EXXEL PACIFIC
GENERAL CONTRACTORS

Request For Information - 112

The Cora Apartments (19 W Harrison)

Subject:	**Kitchenette in Lobby Clarification**	**Status:**	**Open**
Drawing #:	A0201, ID101, ID300	**Spec Sect #:**	
Addendum:		**Submittal #:**

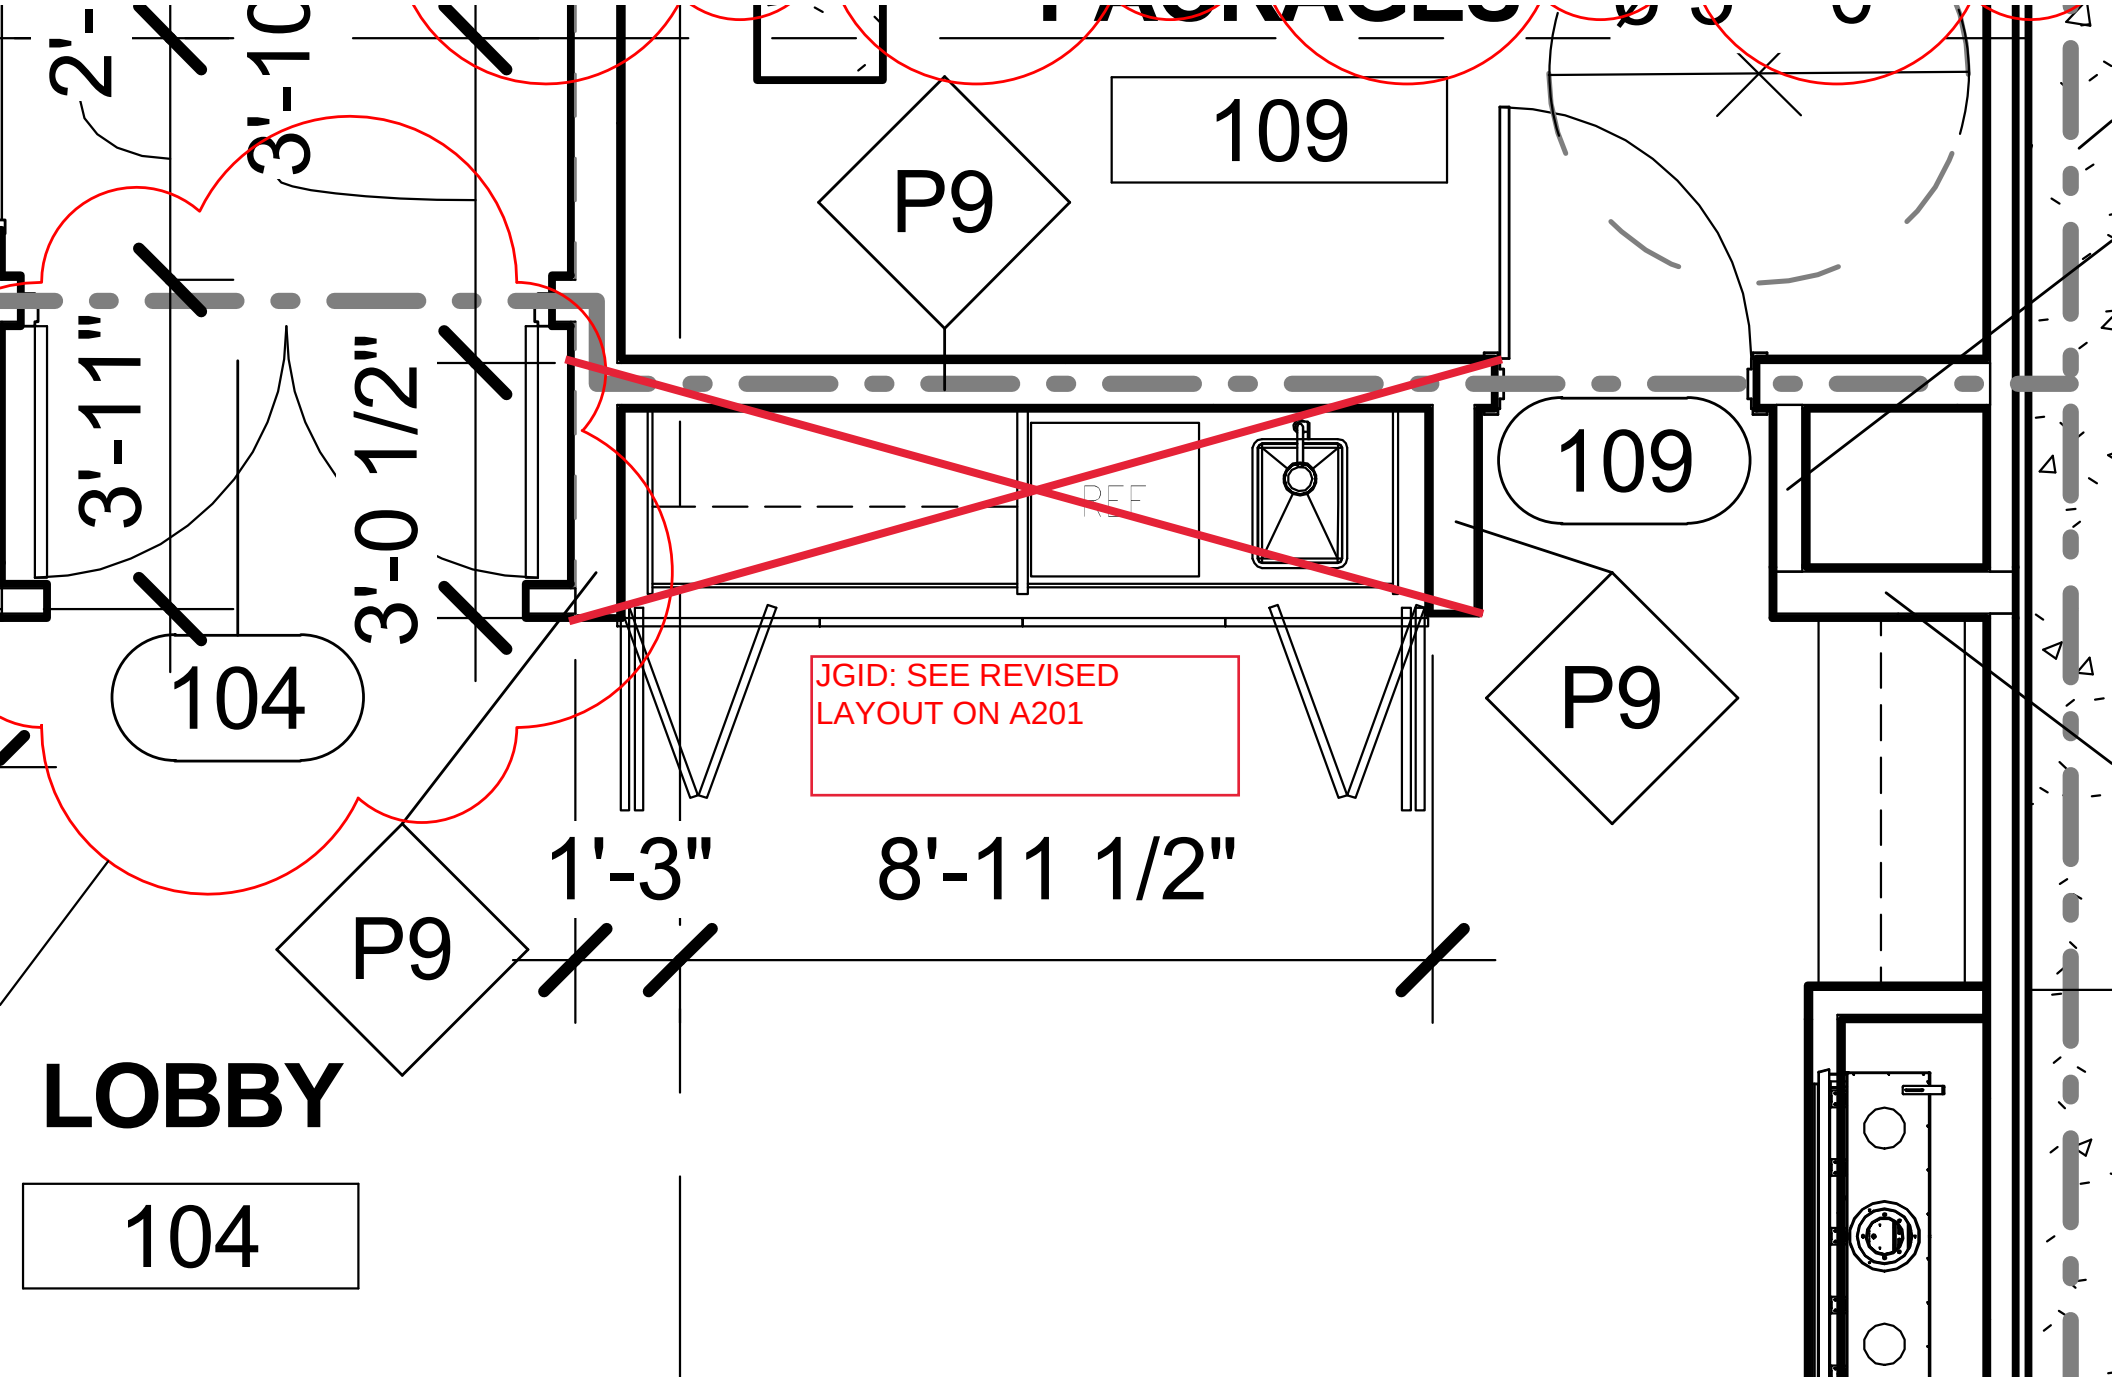
Please verify if the Kitchenette area in the Lobby is to be ADA accessible, and if it the current cabinet layout (see ID 300) meets the ADA requirements. Provide the revised layout if needed. Also, provide detailed information for the material and thickness of the countertop and backsplash. Specify whether the sink is undermount or top mounted, and specify the location of the electrical outlets.

2'-
3'-1C
3'-11"
3'-0 1/2"
104
P9
109
109
P9
P9
REF
JGID: SEE REVISED
LAYOUT ON A201
1'-3"
8'-11 1/2"
LOBBY
104
